Access Compliance Report Public Rights-of-Way (Curb Ramps)

Main Street: SMOKE_TREE_DR Cross Street: SCARLET_MAPLE_DR Location: NW

ADA ID: RPAT211102153103 Ramp Type: Type 4 - Parallel Initial Pass/Fail: Fail Overall Compliance: No Severity Score: 15

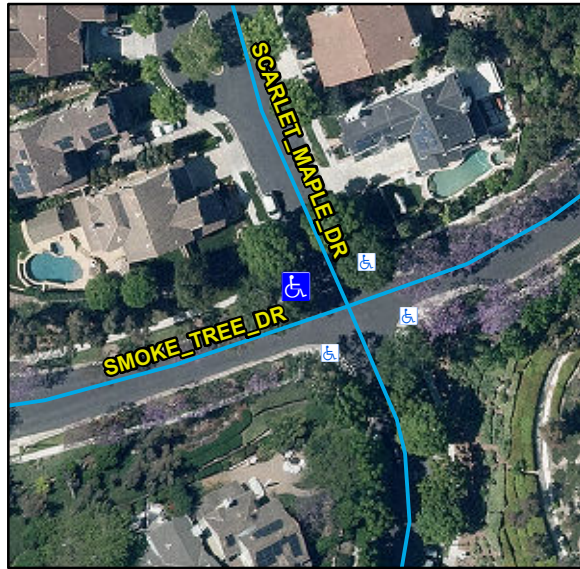
Compliance	Description	Data	Compliance	Description	Data
N/A	Ramp Length LT (in)	109	N/A	Ramp Length RT (in)	102
Yes	Ramp Width LT (in)	54	Yes	Ramp Width RT (in)	54
Yes	Ramp Run Slope LT (%)	2.2	No	Ramp Run Slope RT (%)	11.3
Yes	Ramp Cross Slope LT (%)	1	Yes	Ramp Cross Slope RT (%)	1.1
N/A	Landing Present	N/A	N/A	DWS Provided	N/A
N/A	Landing Length (in)	N/A	N/A	DWS Contrast	N/A
N/A	Landing Width (in)	N/A	N/A	DWS Length (in)	N/A
N/A	Landing Run Slope (%)	N/A	N/A	DWS Full Width	N/A
N/A	Landing Cross Slope (%)	N/A		DWS Offset Type	N/A
N/A	Landing Movement Obstructed?	N/A	N/A	DWS Offset Left (in)	N/A
	Landing Movement Type	N/A	N/A	DWS Offset Right (in)	N/A
N/A	Landing Shared	N/A			
N/A	Clear Space	Yes			
N/A	Clear Space To Crosswalk (in)	N/A			
N/A	Marked Crosswalk 1	No	N/A	Marked Crosswalk 2	No
	Crossing 1 Direction	S		Crossing 2 Direction	E
	Marked Crosswalk 1 Width (in)	N/A		Marked Crosswalk 2 Width (in)	N/A

Remove & Replace Curb Ramp With Two New Directional Ramps or Equivalent.
